City of Rohnert Park Planning Commission Report

AGENDA TITLE:

PLSR17-0009 Site Plan and Architectural Review for a 69,431 square-

foot industrial building

SITE PLAN

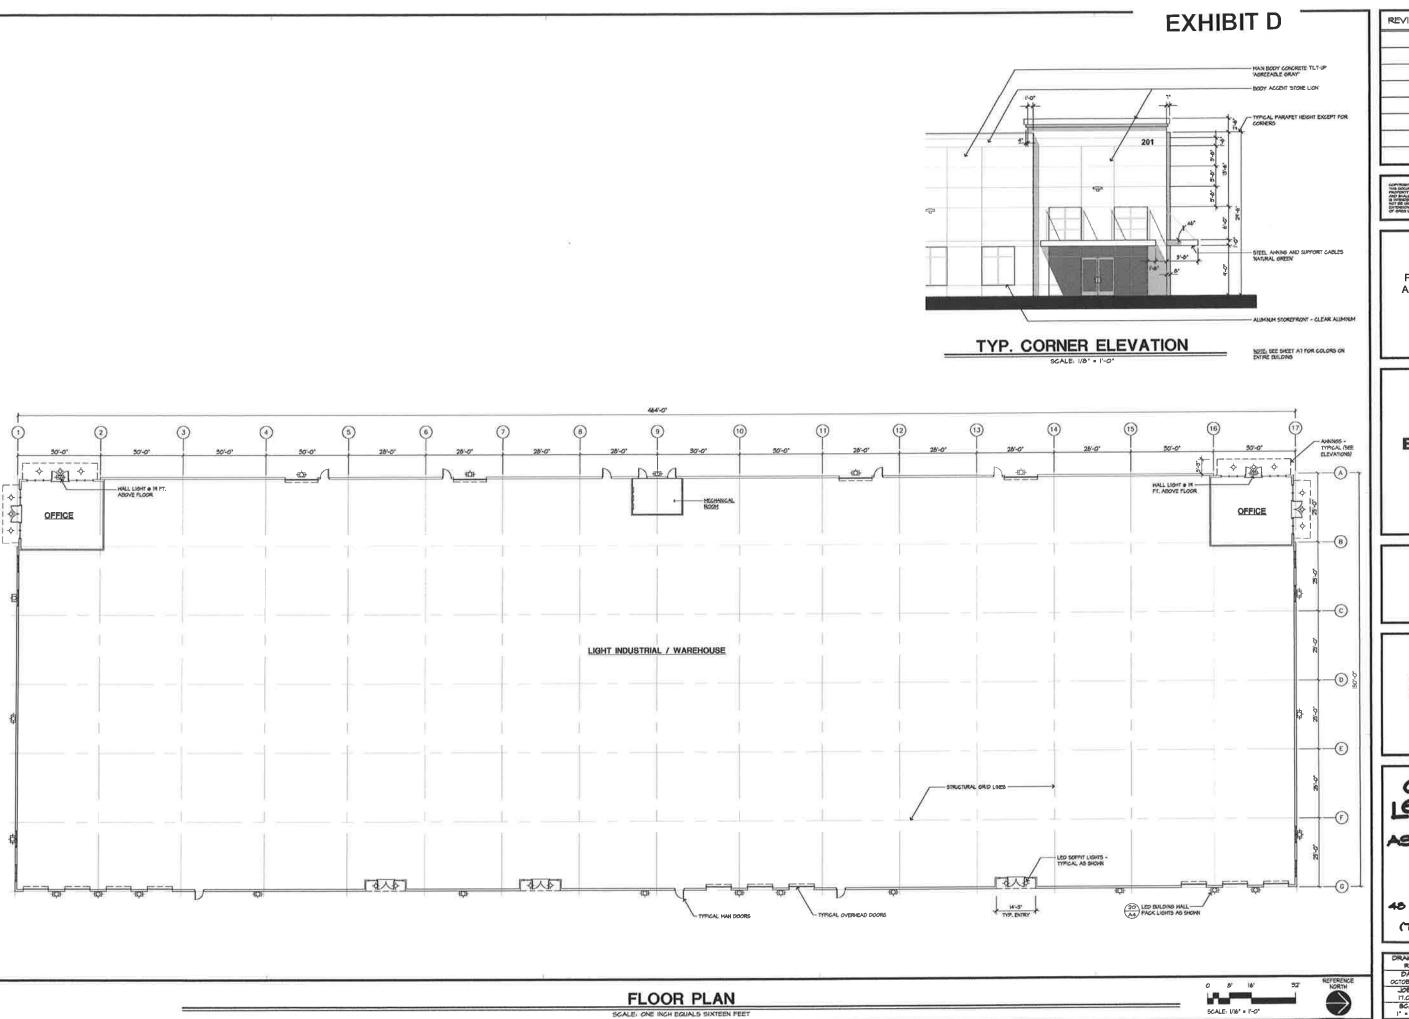
- 1. <u>Parking:</u> This proposal is a typical tilt-up concrete industrial building. The building location results in the maximum building size that the property could accommodate. One concern regarding the size of the building is if adequate parking can be provided. The parking will be adequate if some of the tenants in the building have evening hour operations with few or no employees during the day time hours. It is also possible that the area at the southwest corner of the property could be turned into parking in the future.

- <u>Staff Recommendation</u>: Building occupant are most likely to be large industrial uses without significant parking demand (e.g. fewer employees). Shared parking is also readily available on the site.

LANDSCAPE PLAN

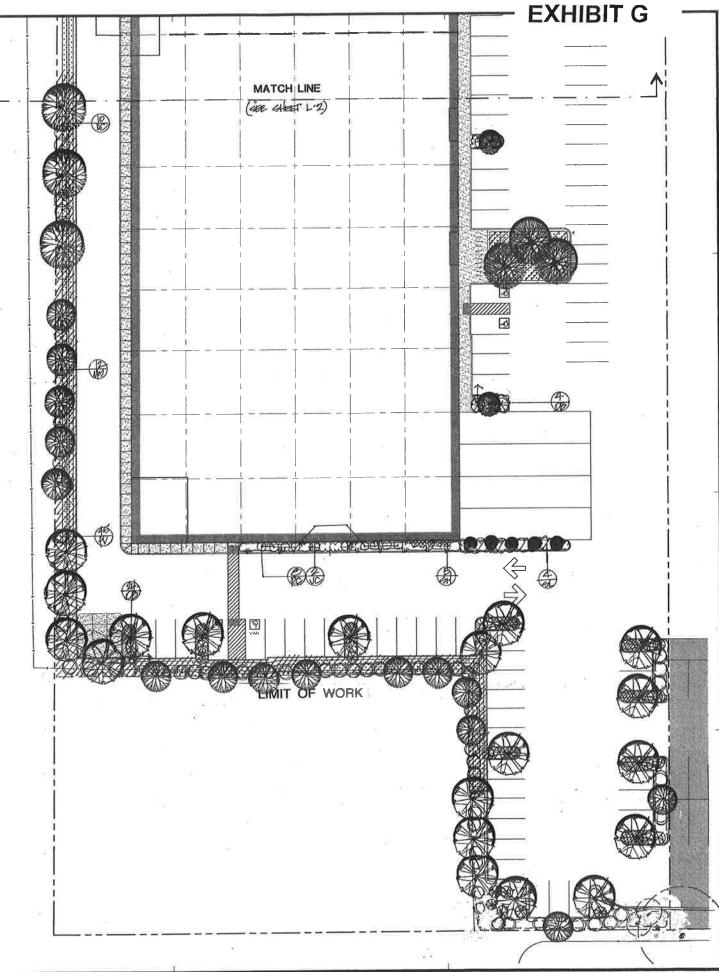
<u>Landscaping</u>- A preliminary landscape concept plan has been submitted. The proposed landscaping consists of a variety of trees, shrubs and ground cover. Trees will be 15 gallons and 24-inch box sizes. It is recommended that some native oak trees be included in the landscape plan.
